**SAN ANTONIO WATER SYSTEM**  
**Olmos Basin Central Watershed Sewer Relief Main (C-3) Project – Line C**  
**SAWS Job No. 08-2512**  
**Solicitation No. B-13-CD-074-RA**

**ADDENDUM NO. 2**

**November 14, 2013**

**Consulting Engineer: Weston Solutions, Inc. TBPE Registration No. F-3123**

NOTES	INITIALS	DATE
DESIGNED BY	AH	11/11/13
REVIEWED BY	MRJ	11/11/13
SCALE:	AS SHOWN	
SHEET NO.	C-06	
	10 OF 48

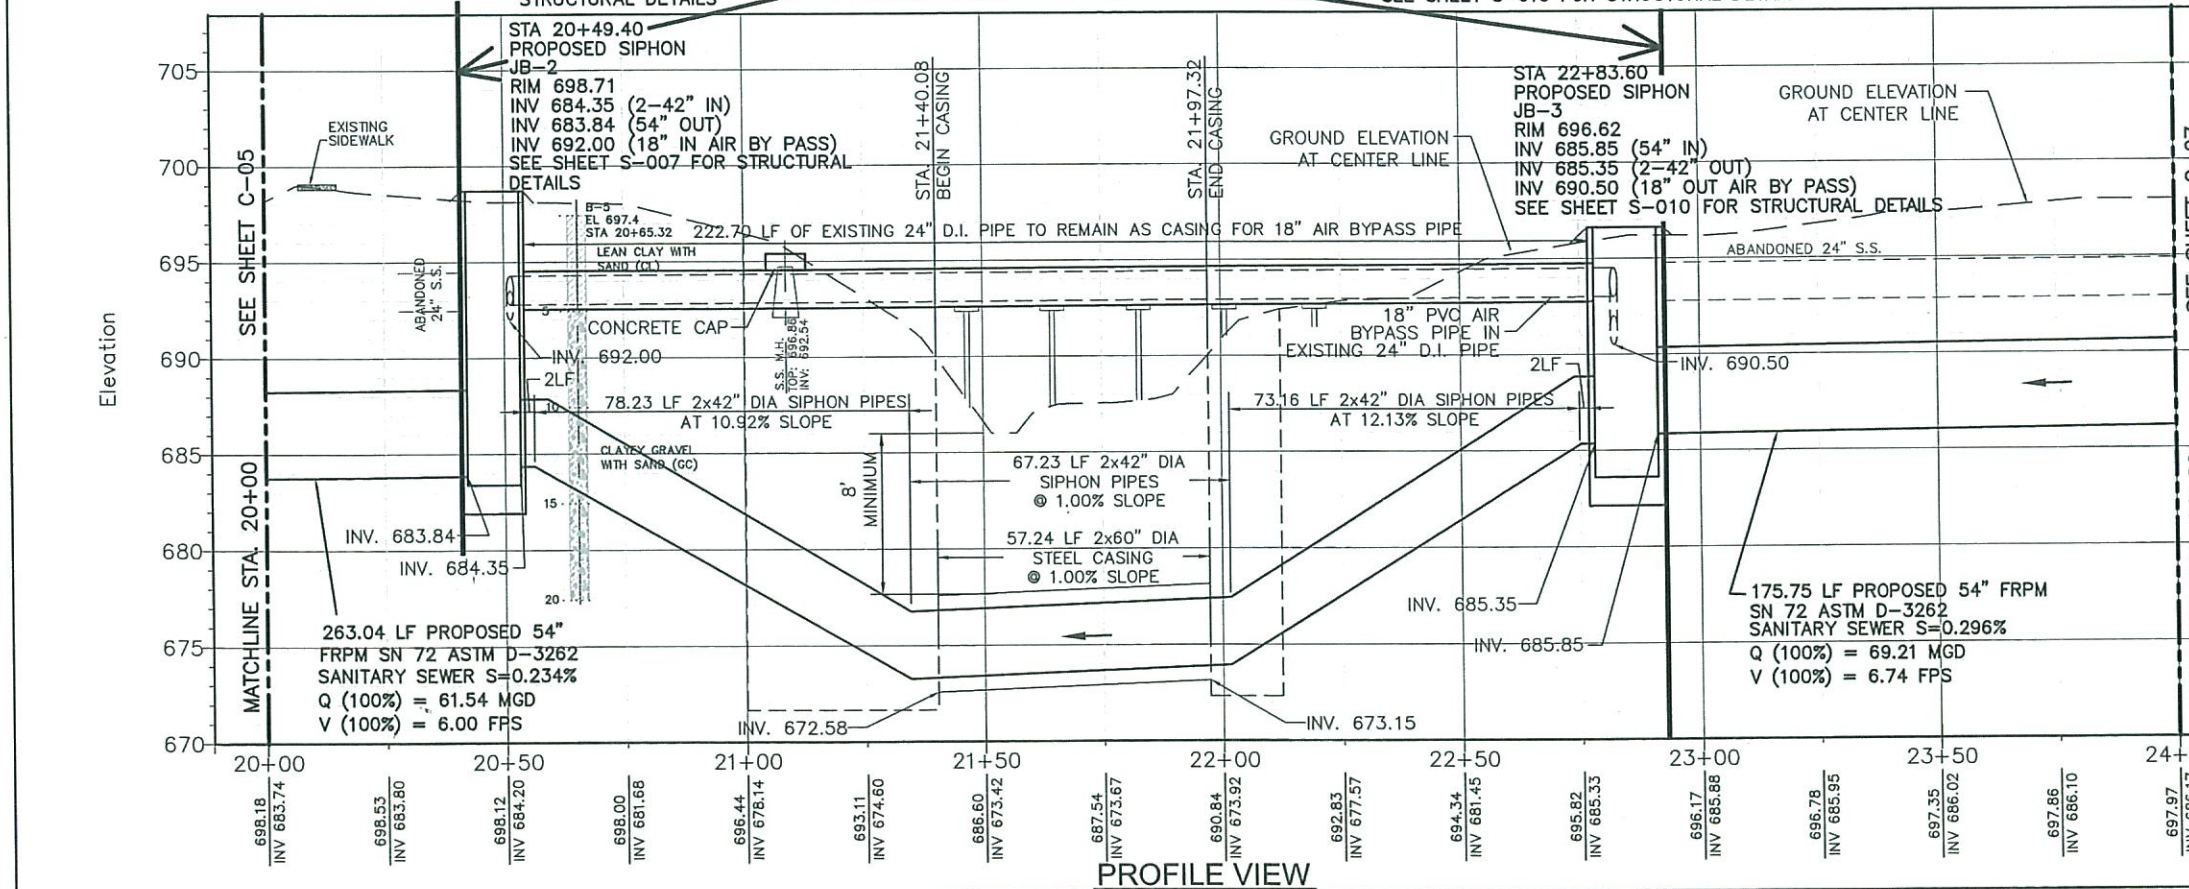
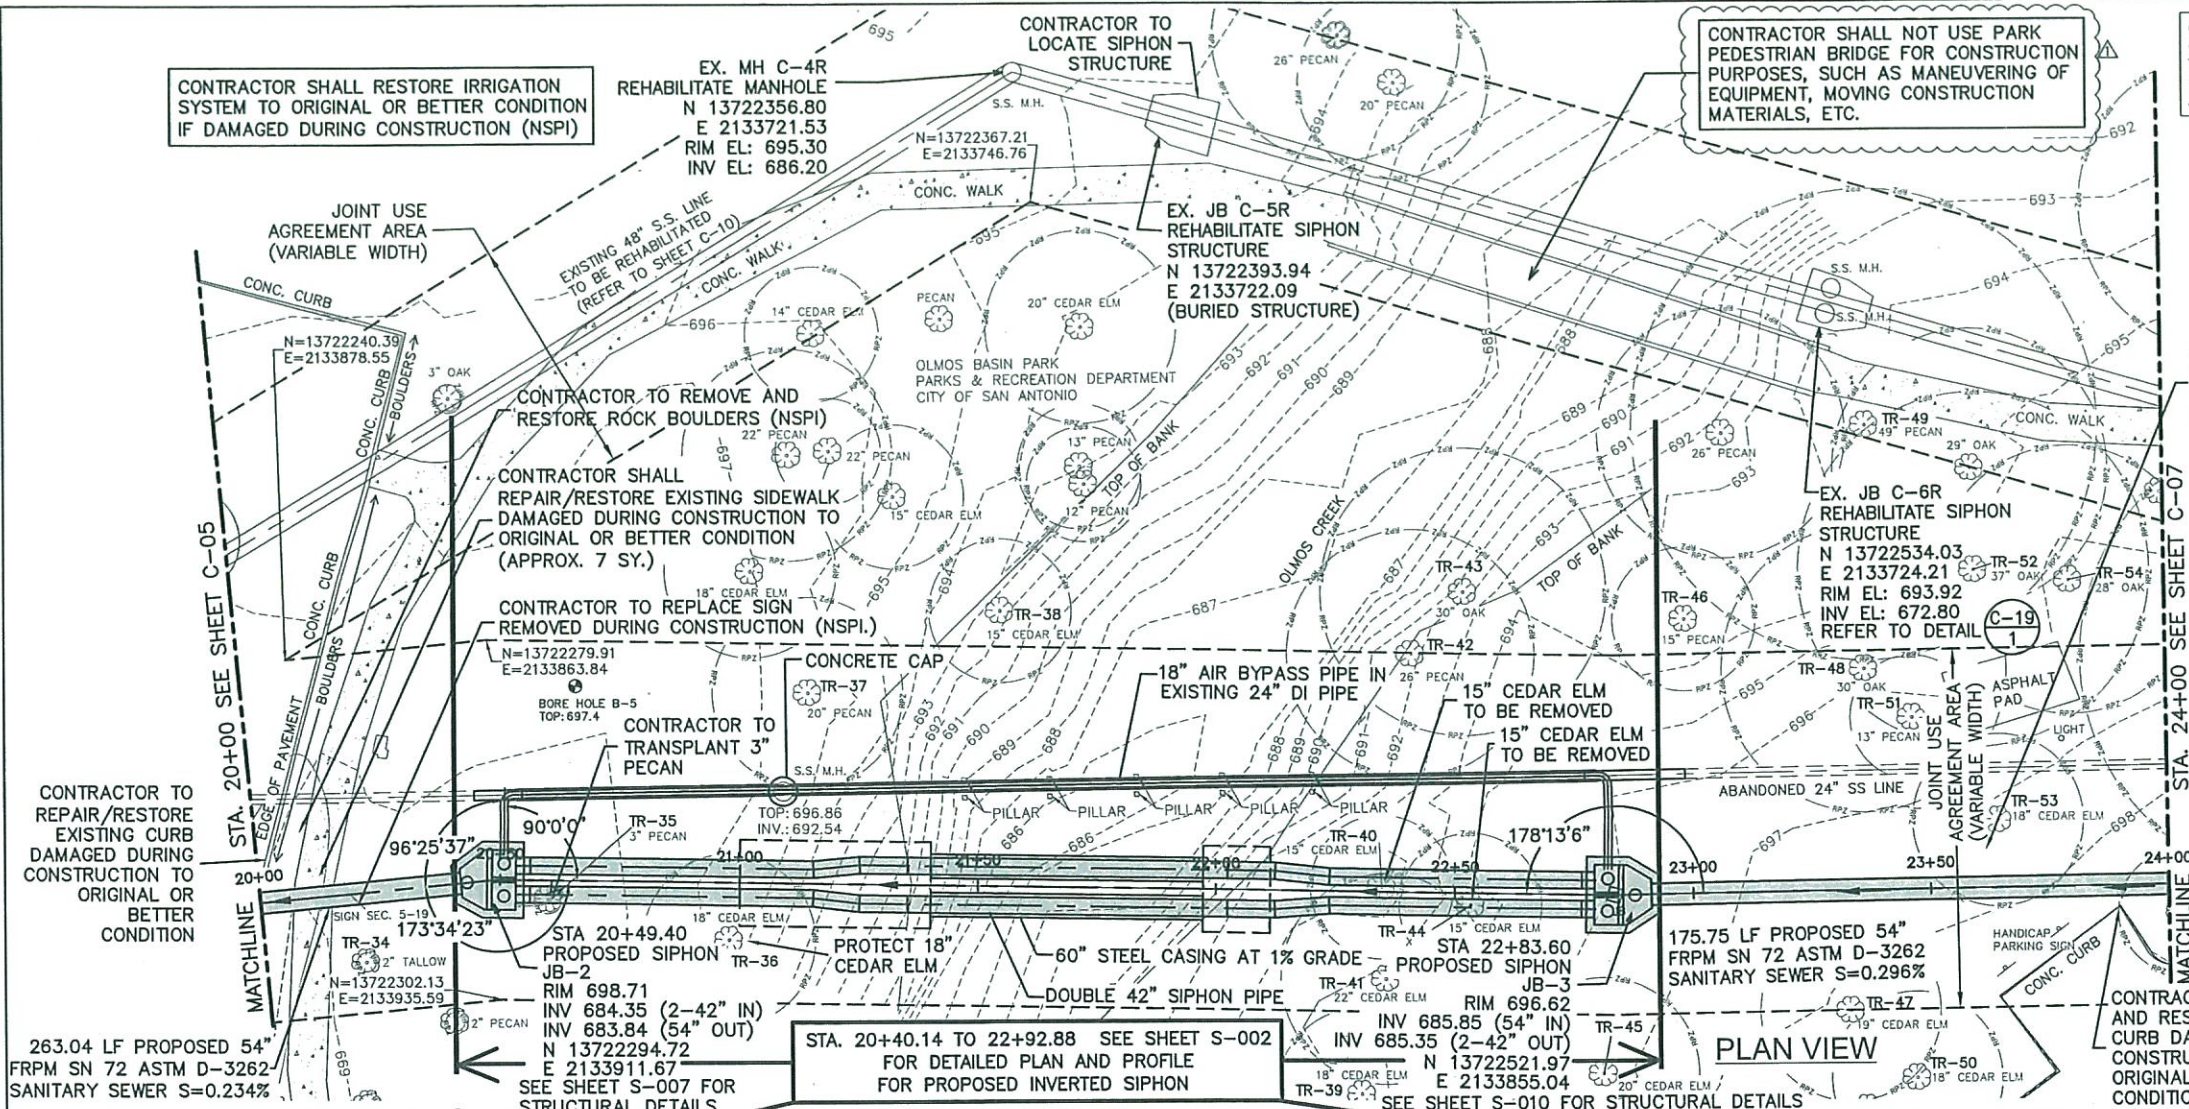
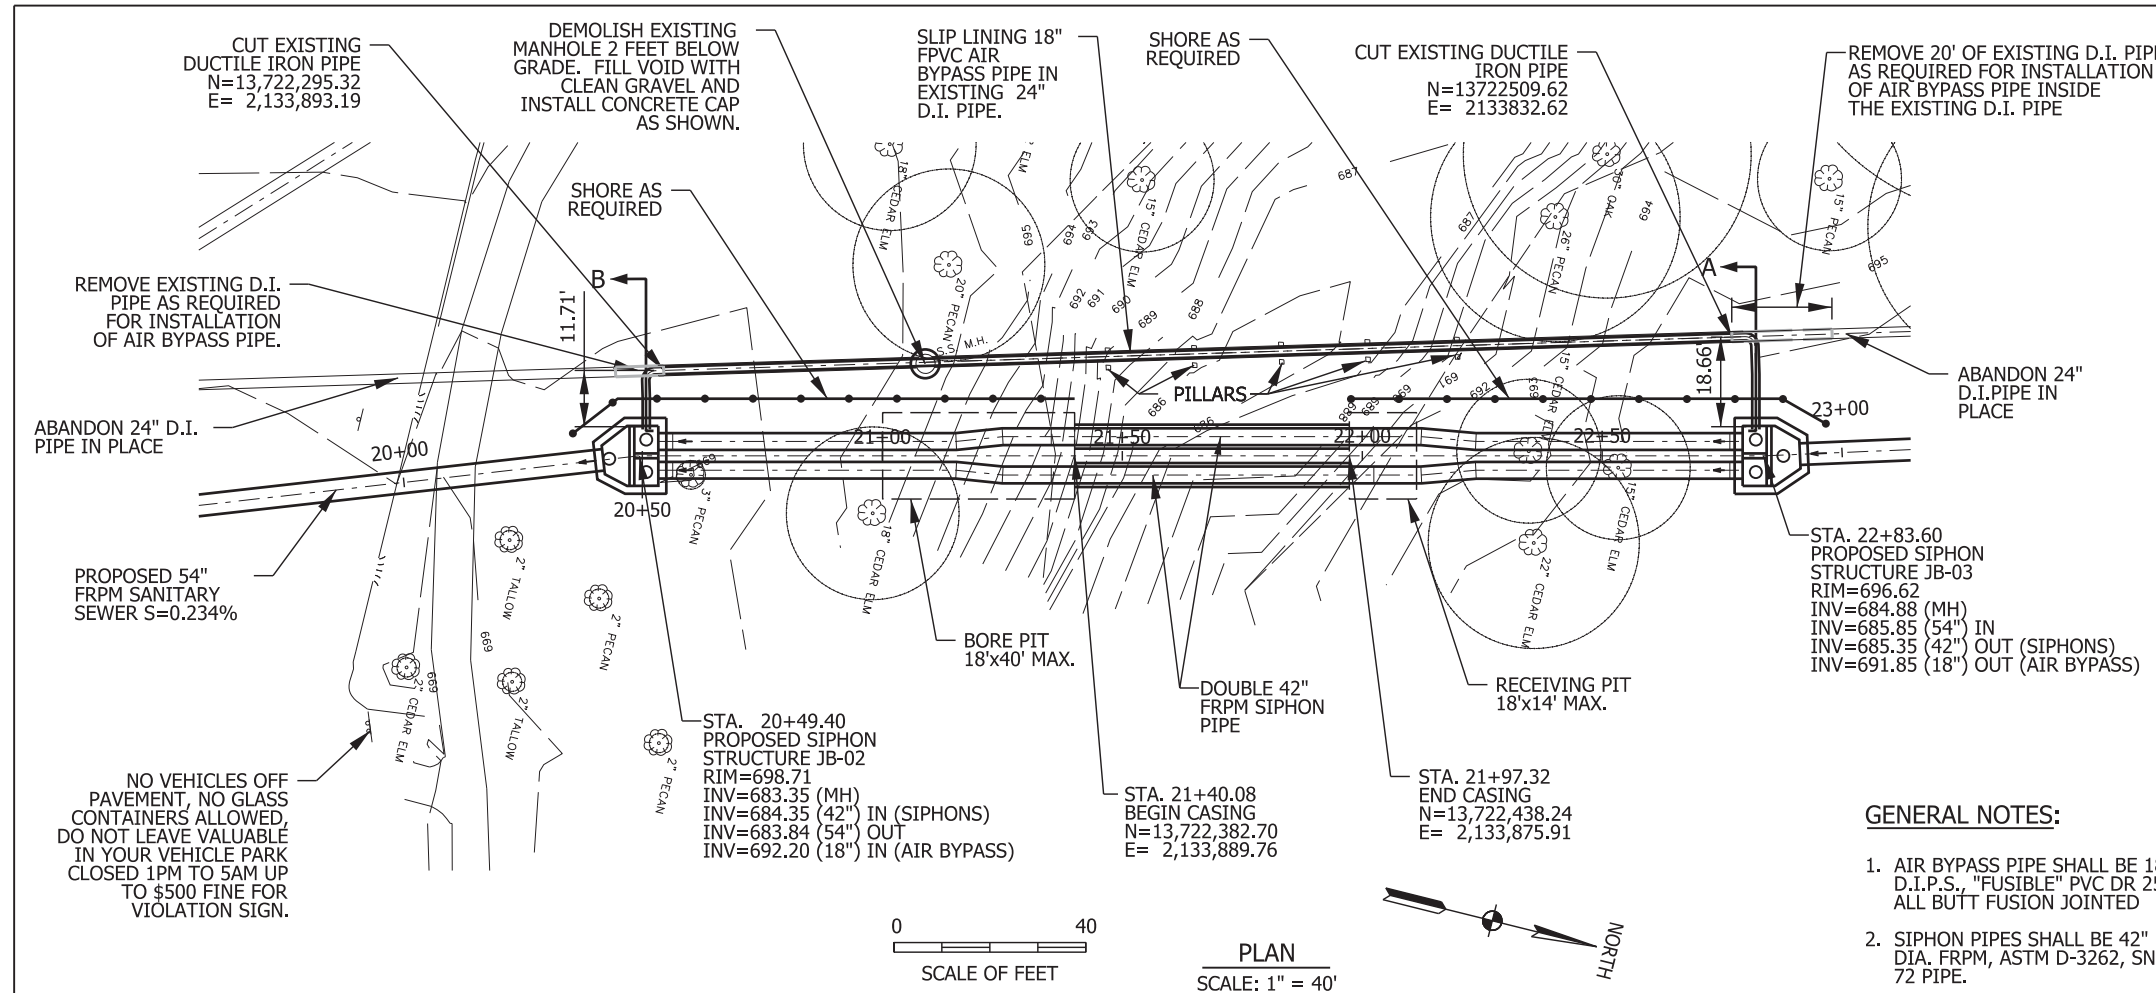
**Item 1:** DELETE **Sheet C-6** in its entirety and REPLACE with the attached **Sheet C-6**, dated 11-11-13.

REV. NO.	DATE	REVISION DESCRIPTION
1	11/11/13	Addendum No. 2

NOTES	INITIALS	DATE
DESIGNED BY	KWC	
REVIEWED BY	KMN	
SCALE:	AS SHOWN	
SHEET NO.	S-2	
	18 OF 48

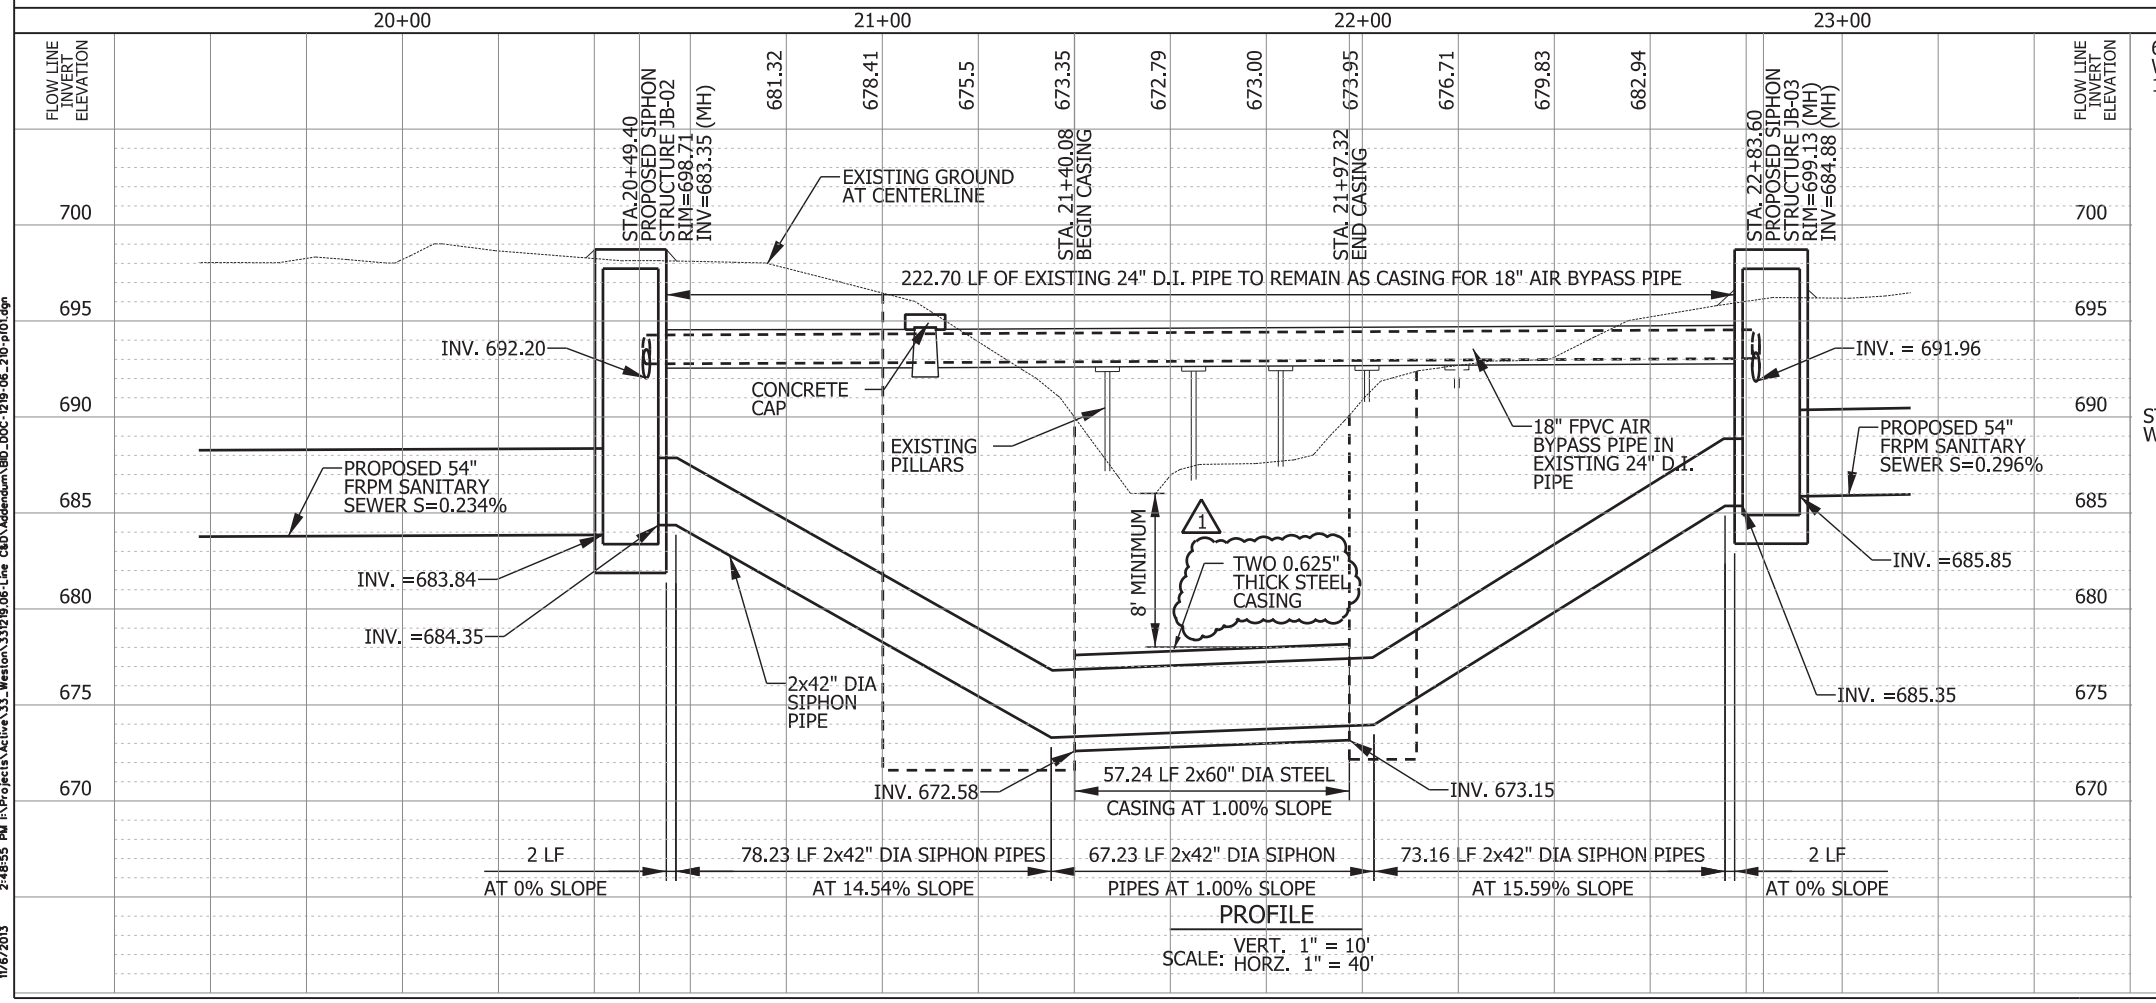
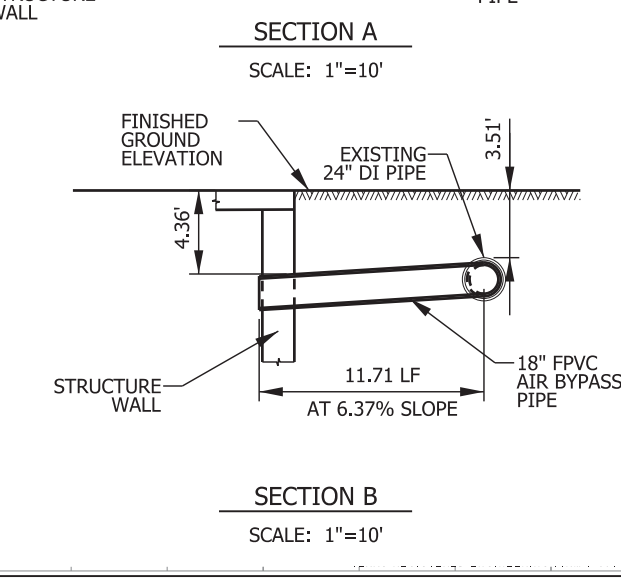
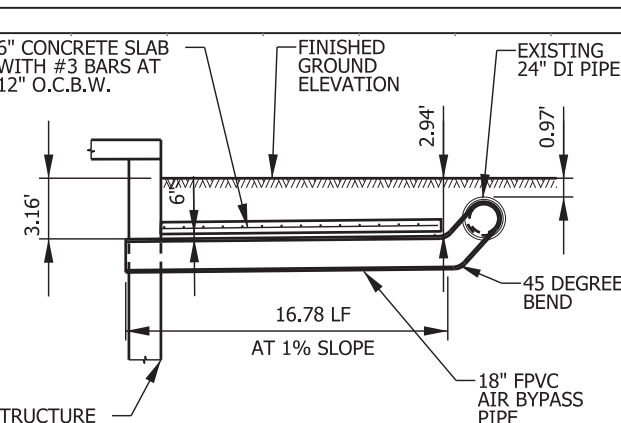
**Item 2:** DELETE **Sheet S-2** in its entirety and REPLACE with the attached **Sheet S-2**, dated 11-7-13.

REV. NO.	DATE	REVISION DESCRIPTION
1	KWC 11/06/2013	REVISED STEEL CASING THICKNESS
